Interactive comment on “Solar irradiances measured using SPN1 radiometers: uncertainties and clues for development” by J. Badosa et al.

Here we supply responses to the referee comments RC C2500 :

Fig. 1. Dome lensing effect diagram

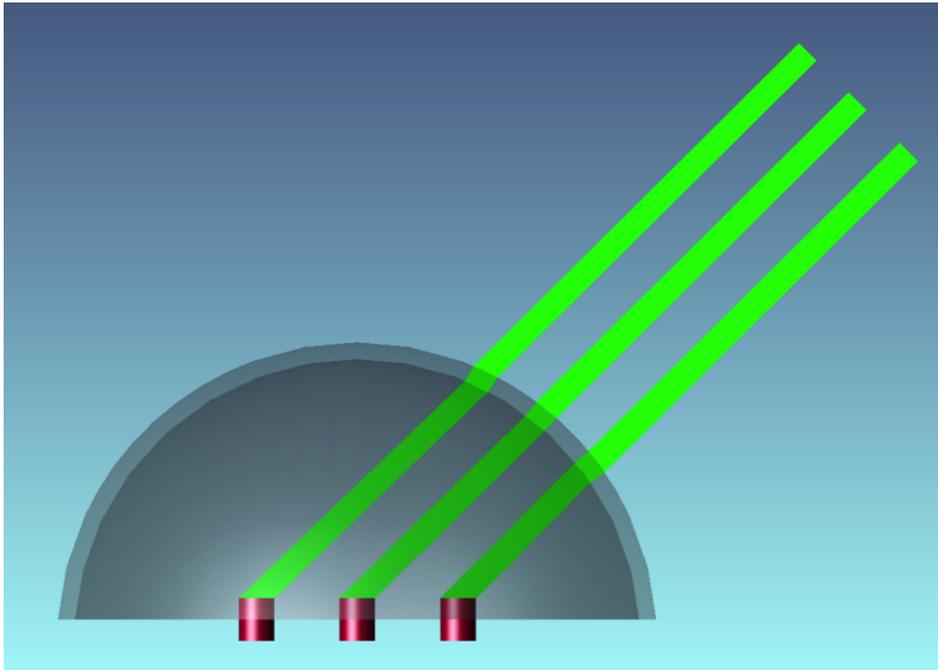
Section 5.1.2, Please, add an figure for this dome lensing effect that explains why nearer (to sun direction detectors have higher response and vice versa. Authors' response:

This diagram in Fig. 1 shows ray traces of parallel rays from the sun incident on the SPN1 detectors, showing the effects of refraction by the glass dome. The effect of this is that the detector furthest from the sun (on the left side of the diagram) absorbs a slightly smaller part of the solar beam than the detector closer to the sun (on the right side of the diagram). We propose to include this diagram as supplementary material. The graph in Fig. 2 shows the percentage variation with zenith angle for the 7 detectors for a 0° of sun position in the SPN1 frame of reference (so not necessarily the solar azimuth).

Fig. 3. Diffuse first touch angle diagram

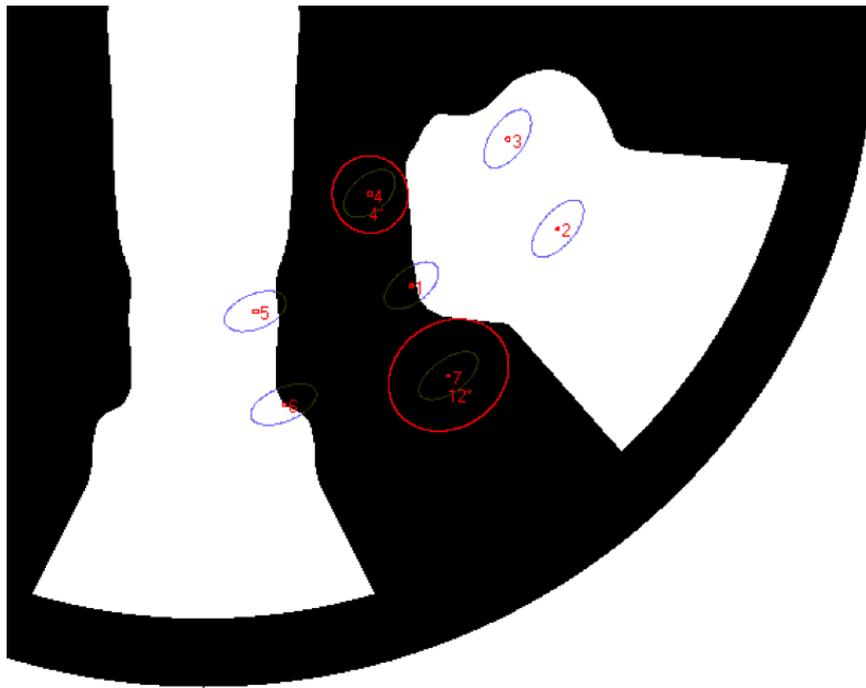
I find "Modelling of SPN1 effective aperture" difficult to understand. Perhaps, an illustration explaining "first touch angle" would help. Authors' response: The diagram in Fig. 3 shows a projection of the 7 detectors onto the shadowmask in the direction of the sun (dark ovals). For the fully shaded detectors, the largest possible cone directed towards the sun that is still fully shaded is drawn (red circles). The half-angle of this cone gives the first touch angle for the detector – in this case 4° for detector 4, 12° for detector 7. The largest first touch angle is taken as the diffuse first touch angle for the given solar position, in this case 12°. The solar aureole out to 12° will be wholly excluded from the diffuse measurement in this case. We propose to include this figure as the supplementary material.
